**PITTMAN TERRACE WATER QUALITY IMPROVEMENT PROJECT  
GLENBROOK, NEVADA**

## ADDENDUM NO. 1, Page 2 of 3

FRIEDHOFF DRIVE DRAINAGE  
PITTMAN TERRACE WATER QUALITY  
IMPROVEMENT PROJECT

*G-1*  
4 OF 14

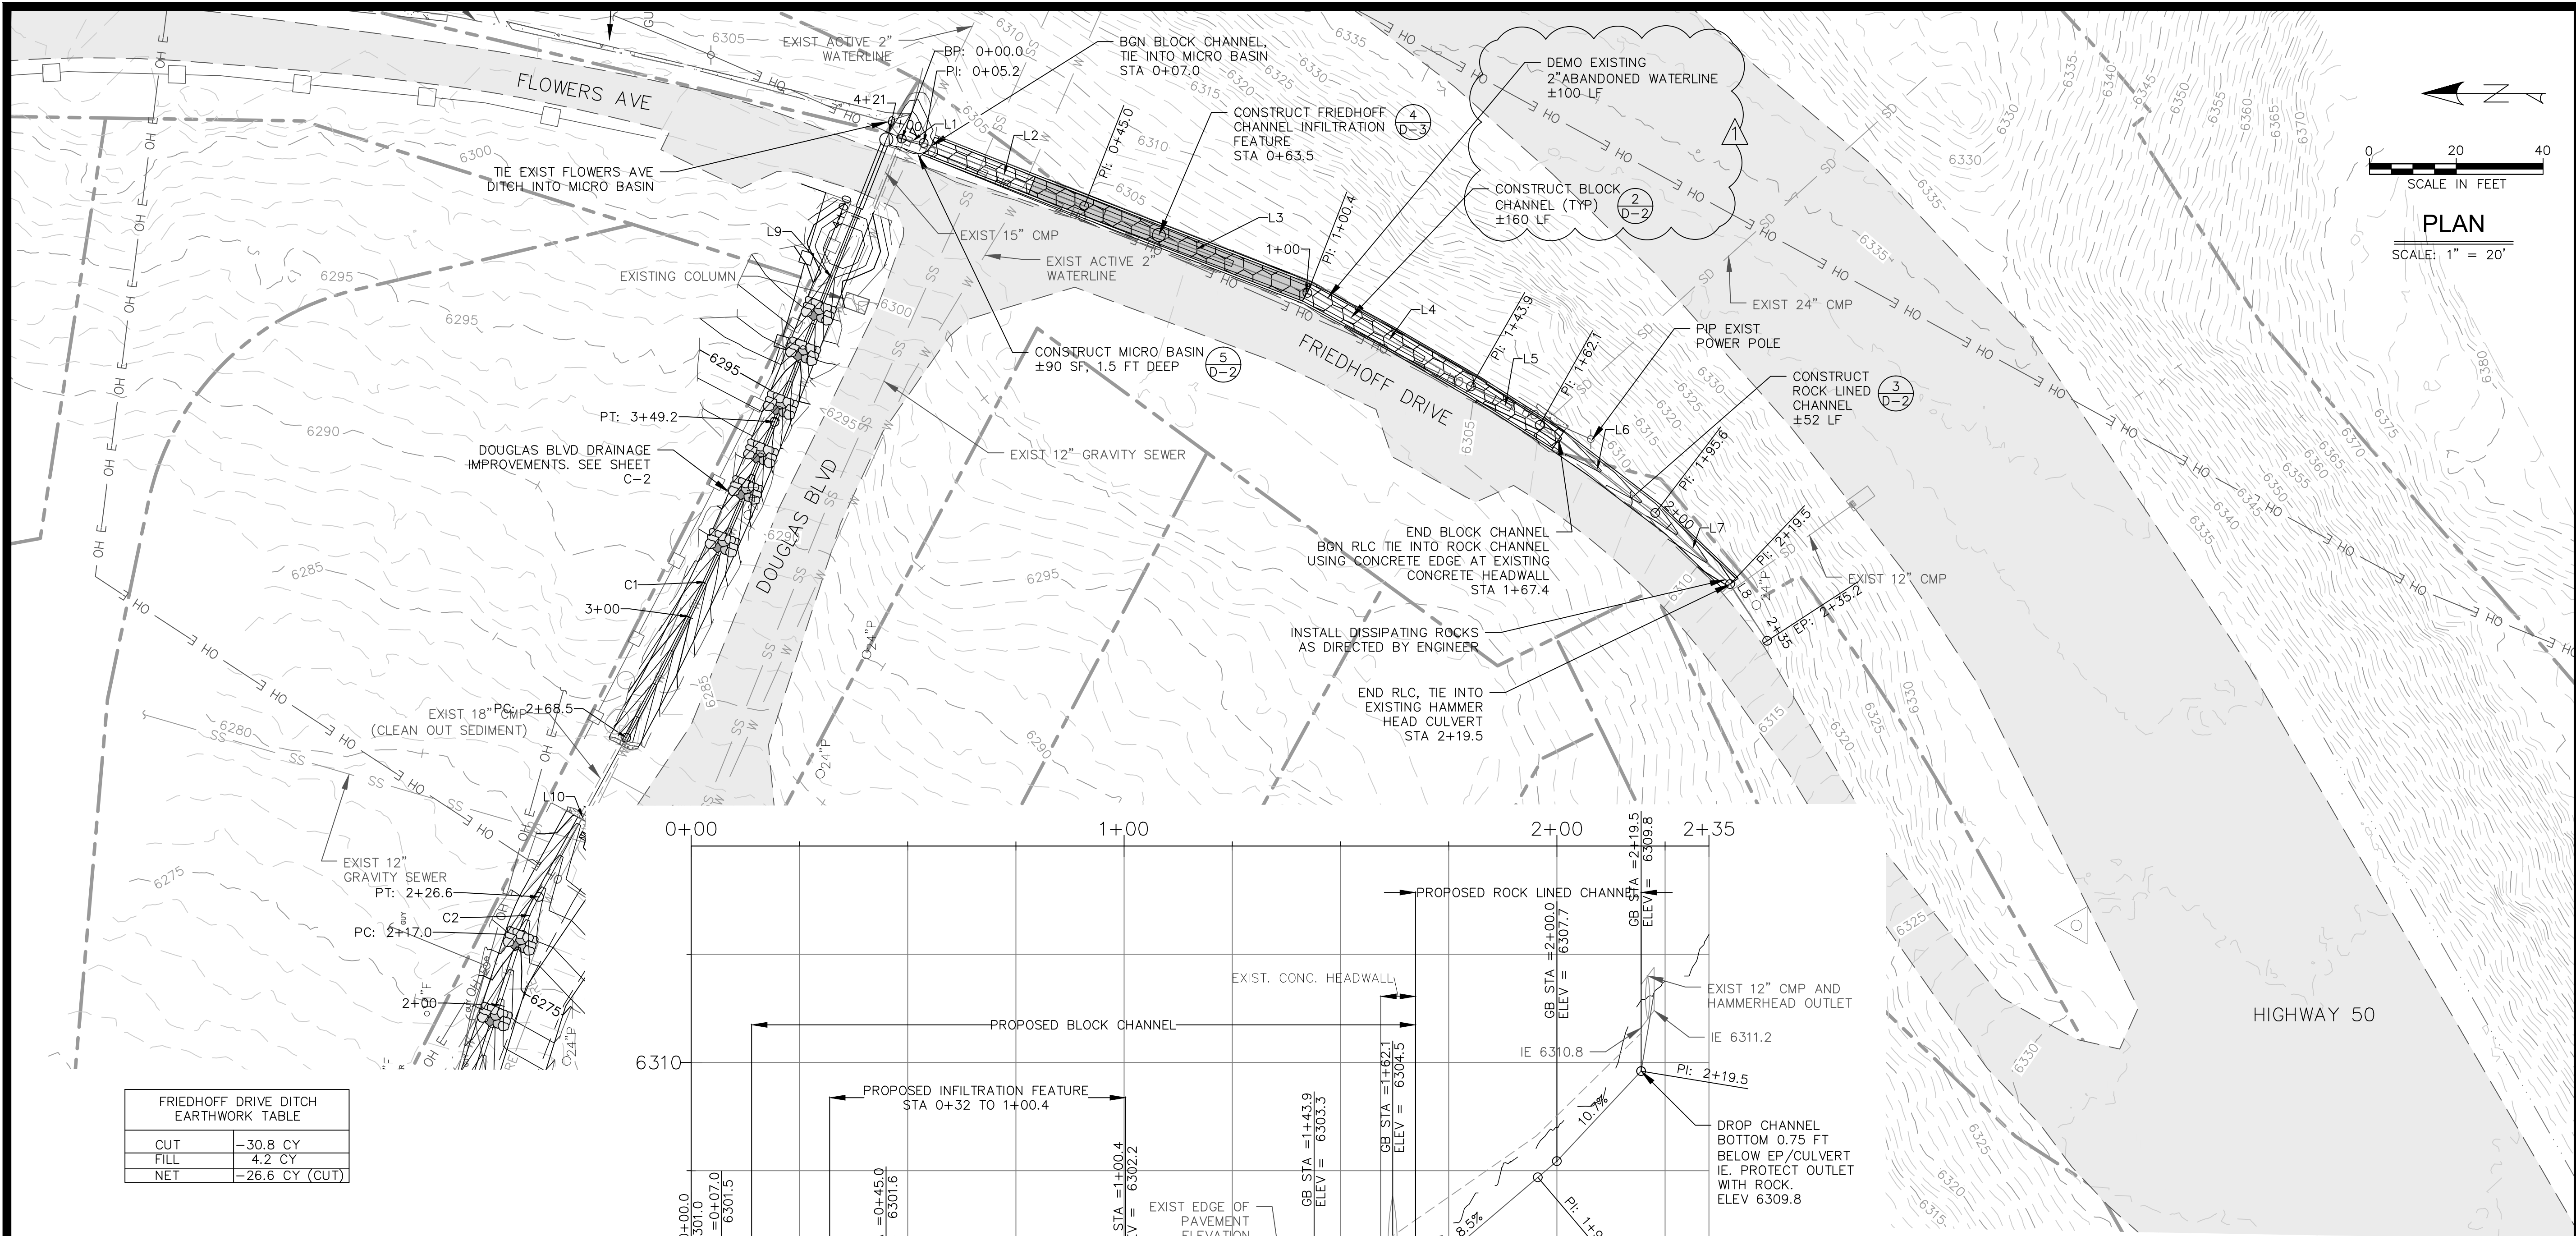
1. Sheet G-1: Protection for Staging Area 2 must be per MUTCD code, NDOT standard specification, and the NDOT encroachment permit. Contractor shall submit the proposed protections for Staging Area 2 to NDOT in the traffic control plan to be submitted per Section 150 of the Special Technical Provisions.

C-4

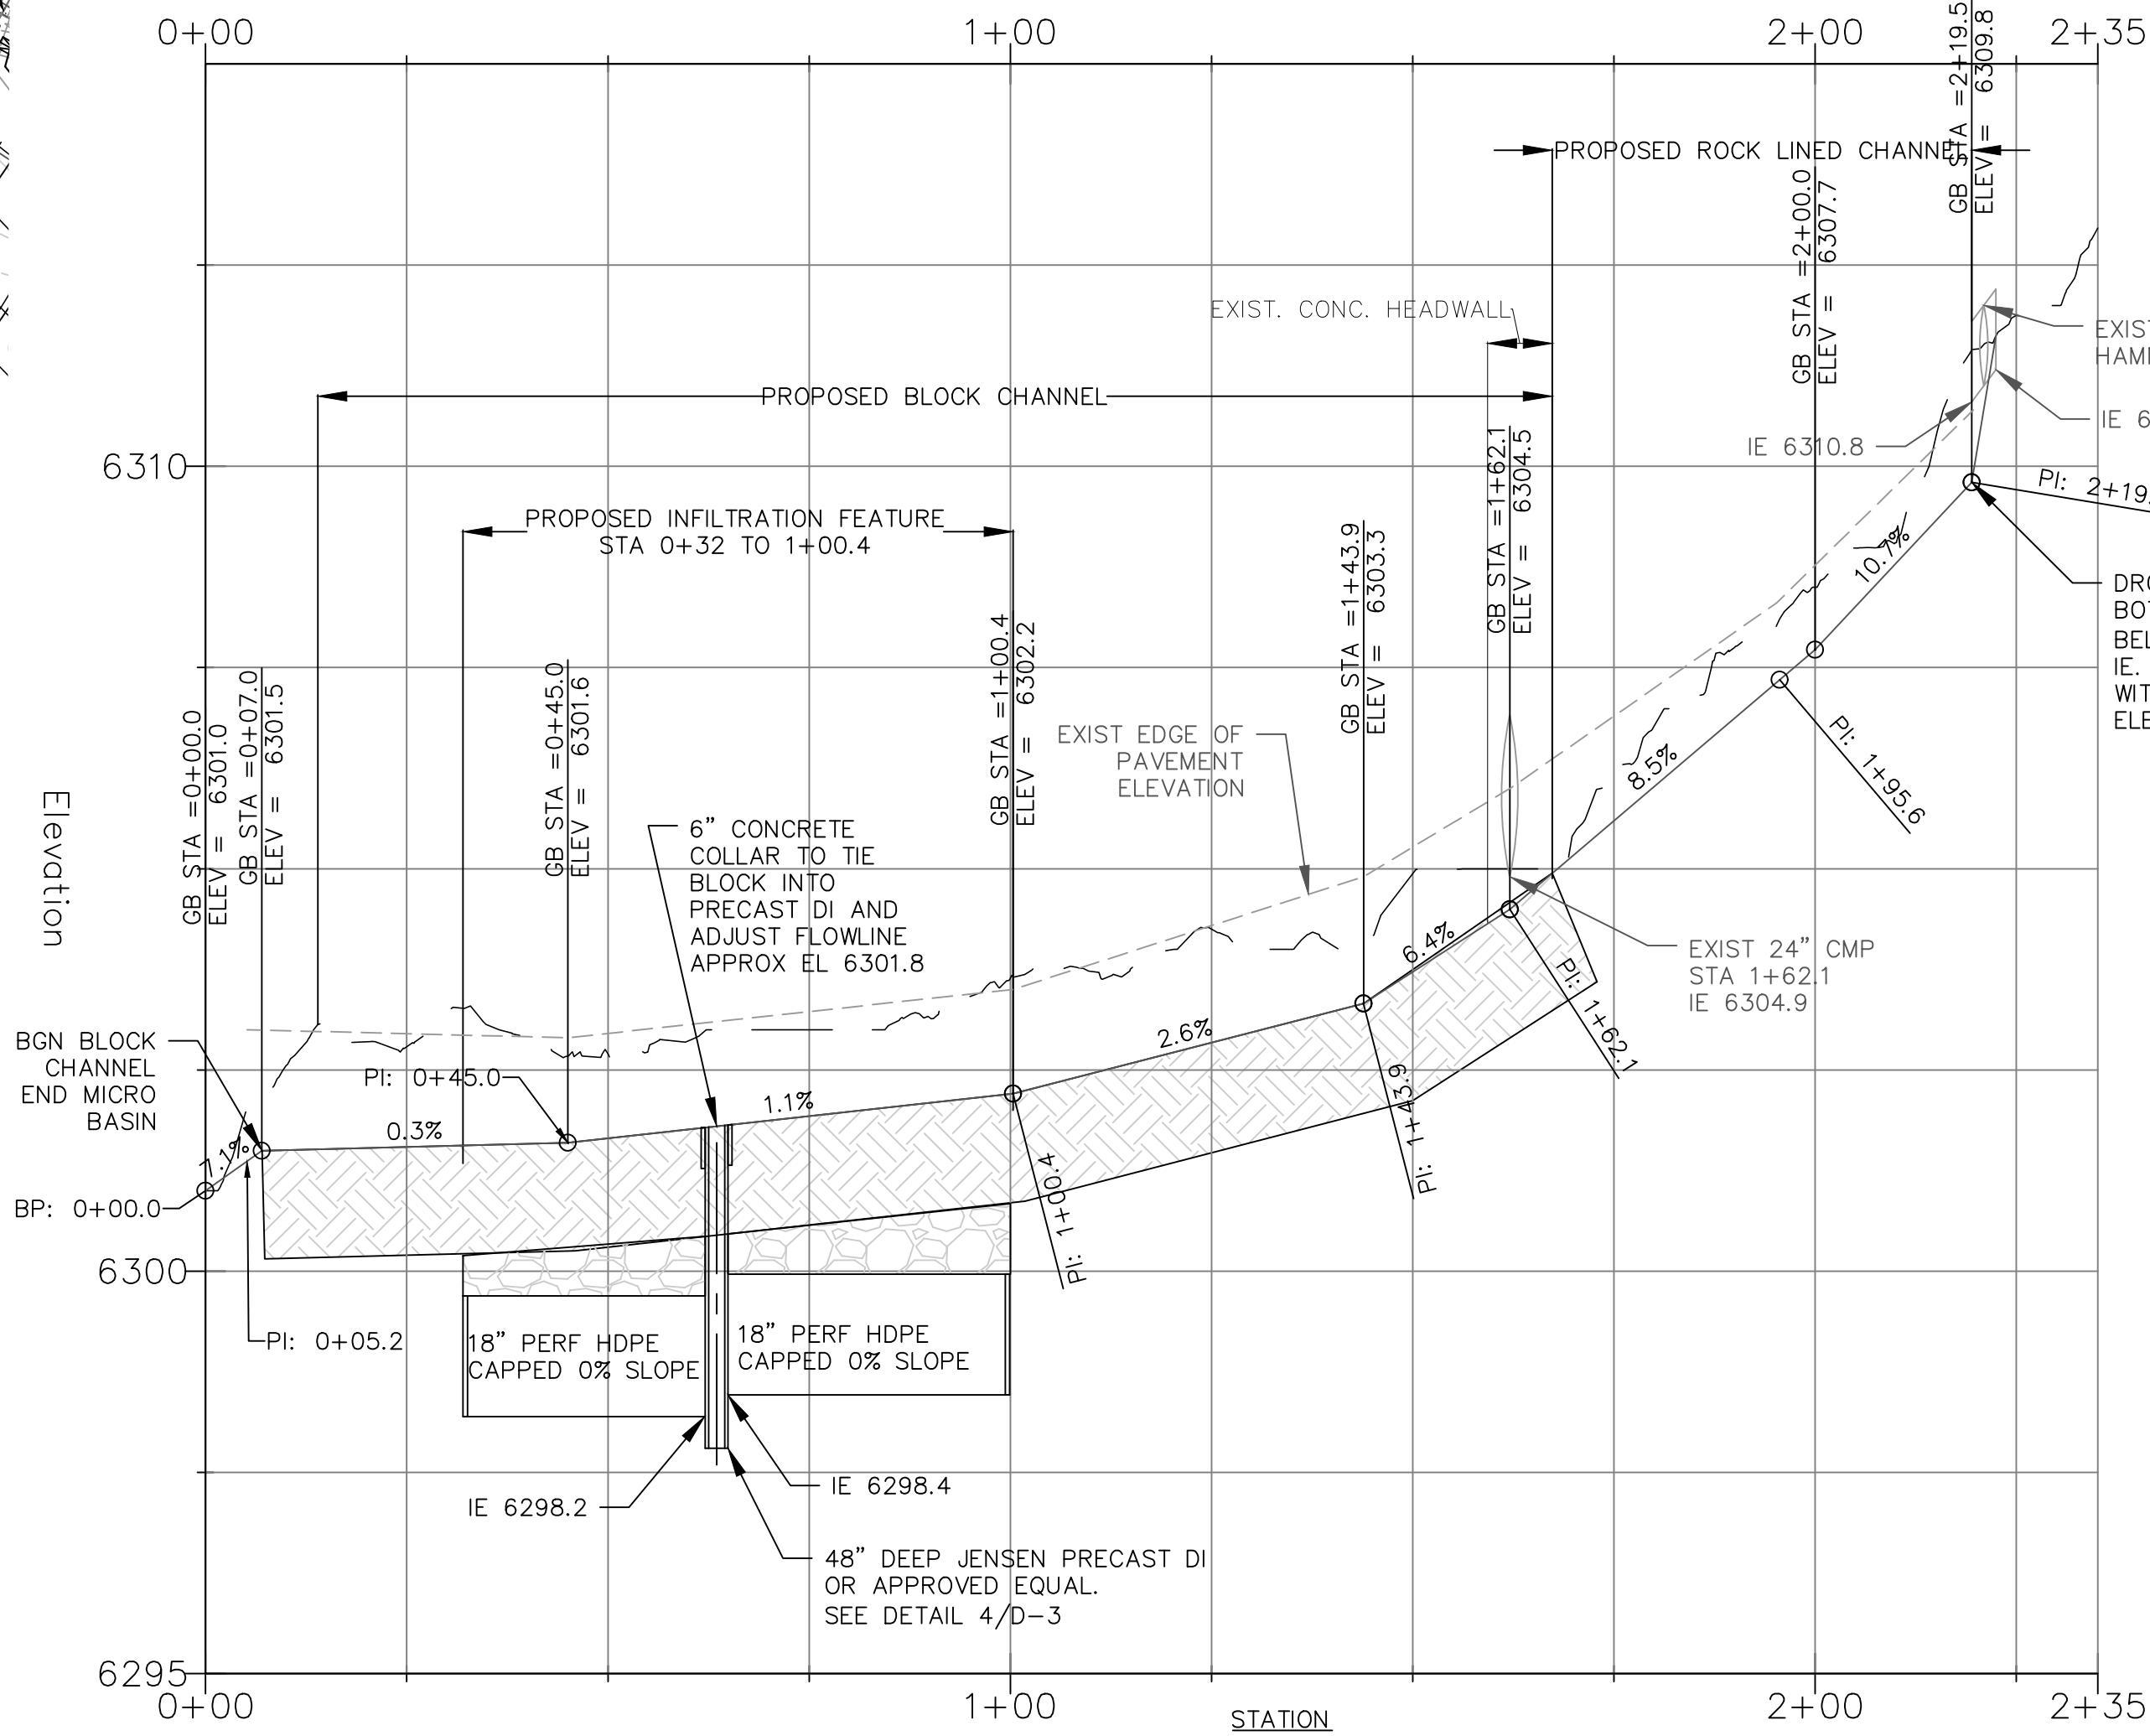
2. Sheet C-4: An existing 2" abandoned metal water line is present in the existing Friedhoff Drive ditch. Contractor to remove +/- 100 linear feet of abandoned pipe. Demolition shall be included in the lump sum of Bid Item 4, "Demolition and Existing Infrastructure".

3. Sheet C-4: Block channel quantity has been changed from +/- 100 linear feet to +/- 160 linear feet. The bid schedule has also been amended.
4. Sheet R-1: The rock line channel will not include revegetation treatment. The treatment type 1 area has been changed to show exclusion and the quantity of revegetation amended to +/- 6,150 square feet.

REVEGETATION PLAN  
PITTMAN TERRACE WATER QUALITY  
IMPROVEMENT PROJECT

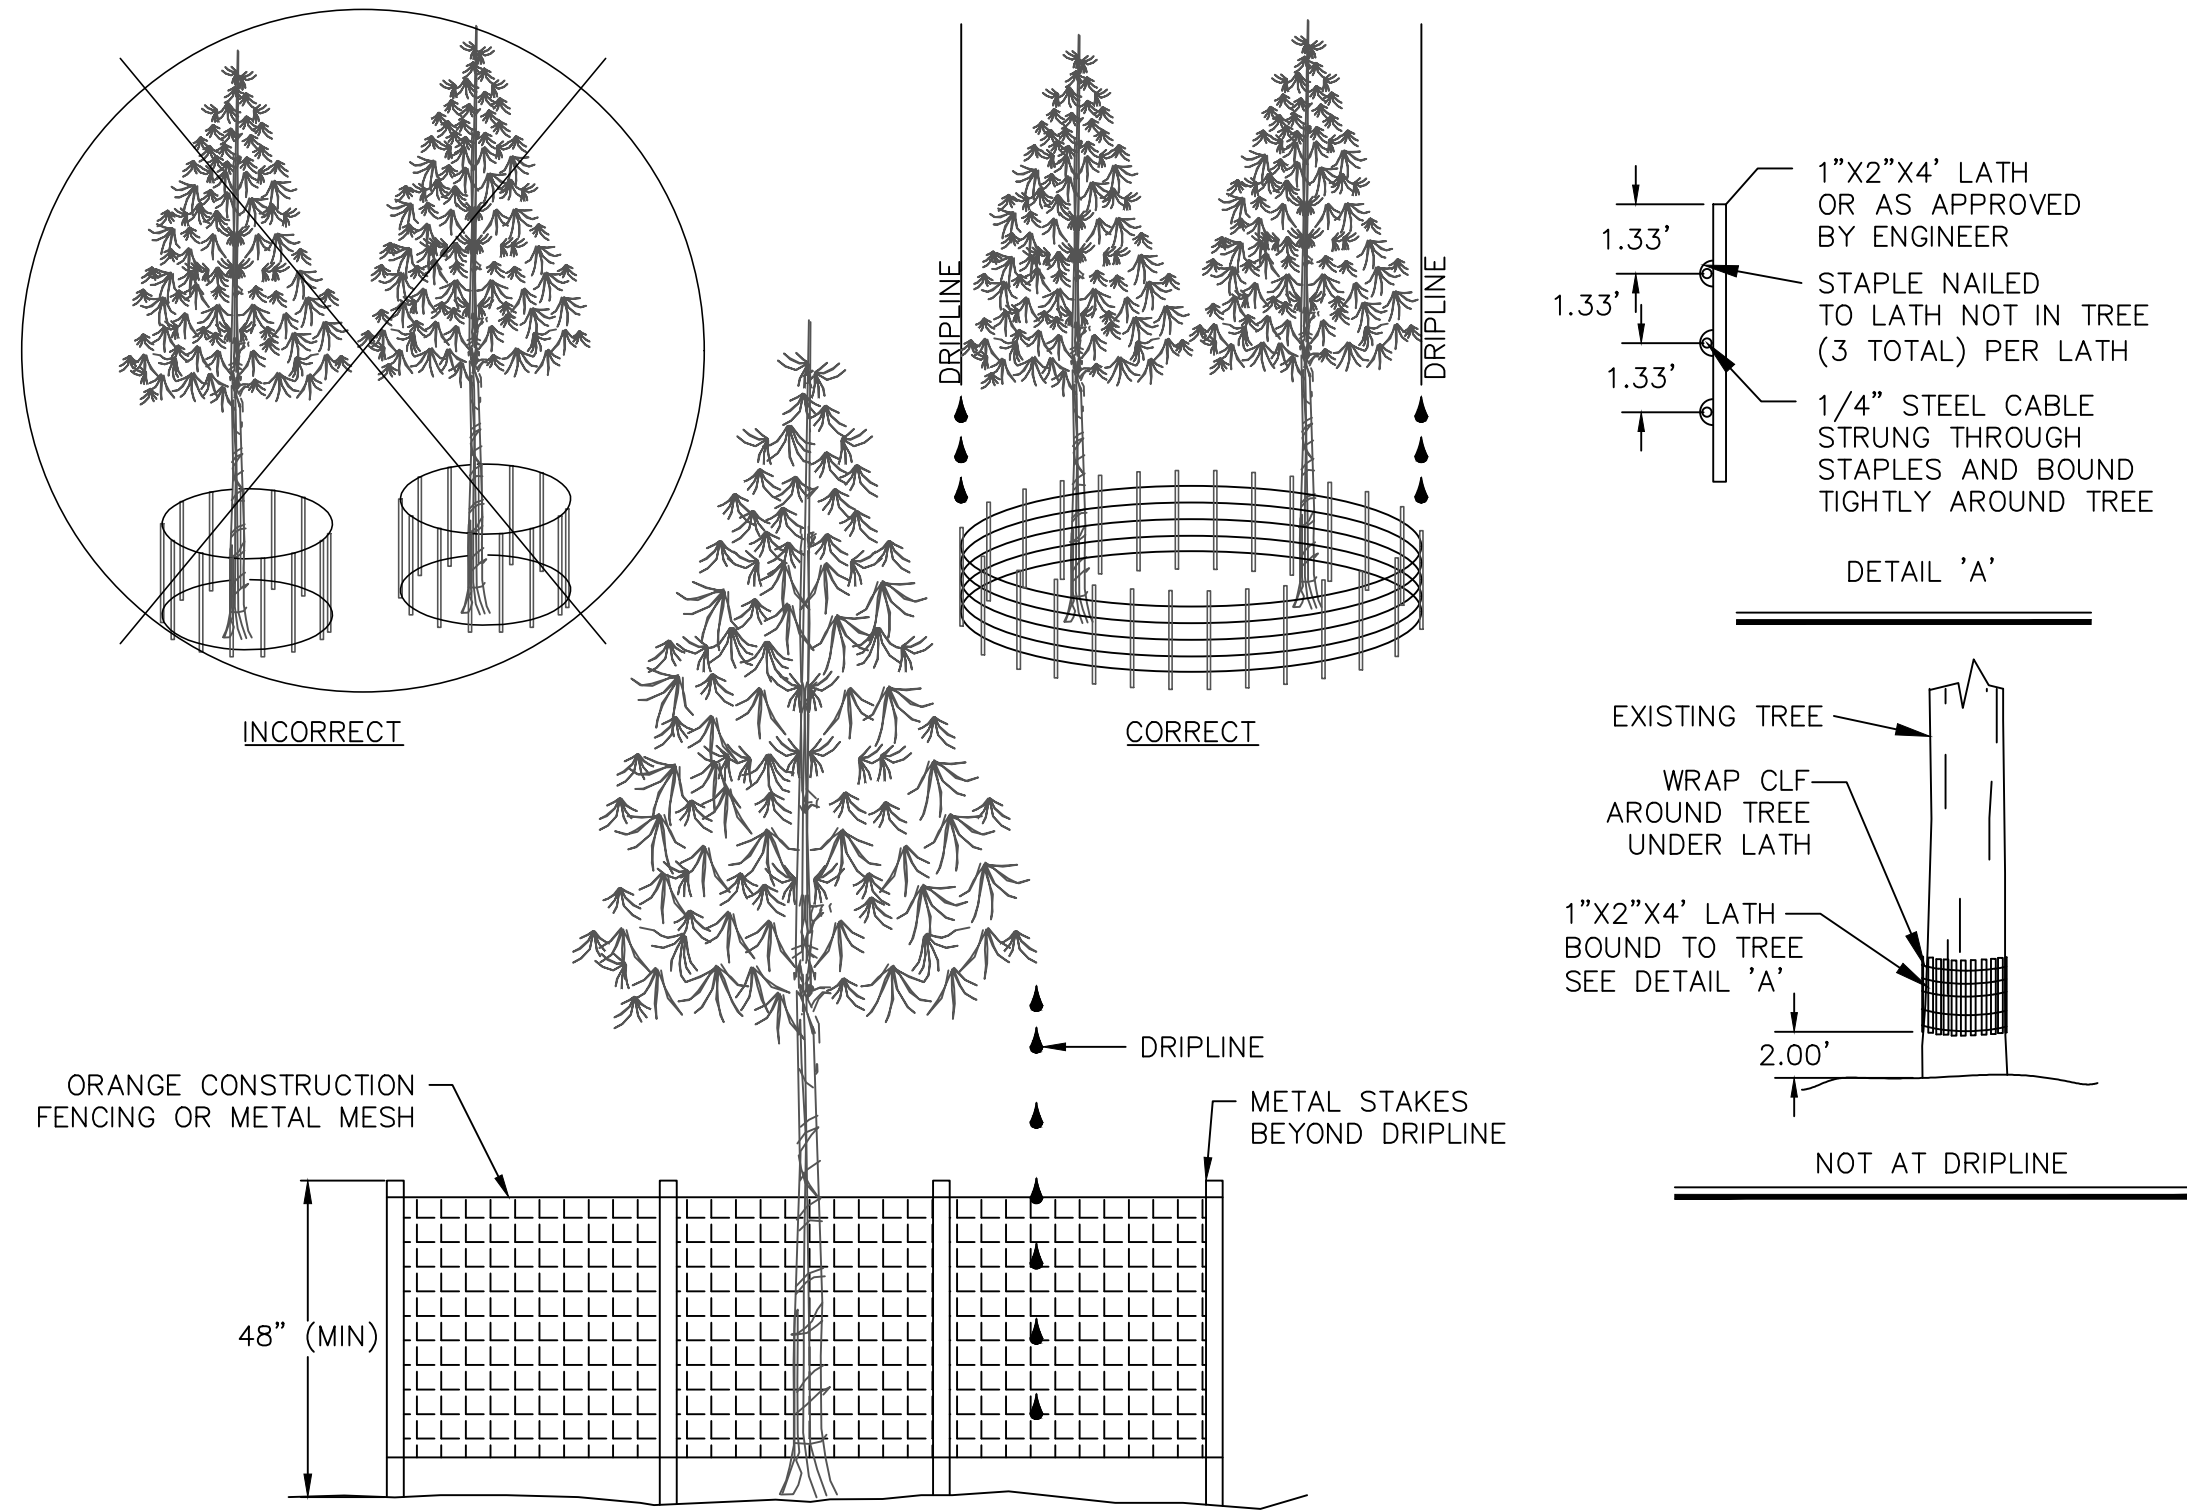
5. Sheet R-1: A call out has been added to the existing private water system where construction and irrigation water may be obtained from the private water purveyor. A second note was added to the sheet concerning the connection as follows: "2. CONSTRUCTION AND IRRIGATION WATER MAY BE OBTAINED WITH COORDINATION WITH PRIVATE WATER PURVEYOR (VANCE AND RORY KEENEY). A HOSE BIB AND METER WOULD NEED TO BE INSTALLED AT SHOWN JUNCTION POINT TO ACCESS WATER. ALL WATER LINE WORK TO BE COMPLETED BY PRIVATE WATER PURVEYOR."

6. Sheet R-1: A third note has been added to the sheet concerning irrigation requirements as follows: "3. IRRIGATION IS ONLY REQUIRED FOR WORK ALONG DOUGLAS BLVD."

- NOTES:
1. SEE SPECIAL PROVISIONS FOR REVEGETATION DETAILS.
  2. CONSTRUCTION AND IRRIGATION WATER MAY BE OBTAINED WITH COORDINATION WITH PRIVATE WATER PURVEYOR (VANCE AND RORY KEENEY). A HOSE BIB AND METER WOULD NEED TO BE INSTALLED AT SHOWN JUNCTION POINT TO ACCESS WATER. ALL WATER LINE WORK TO BE COMPLETED BY PRIVATE WATER PURVEYOR.
  3. IRRIGATION IS ONLY REQUIRED FOR WORK ALONG DOUGLAS BLVD.
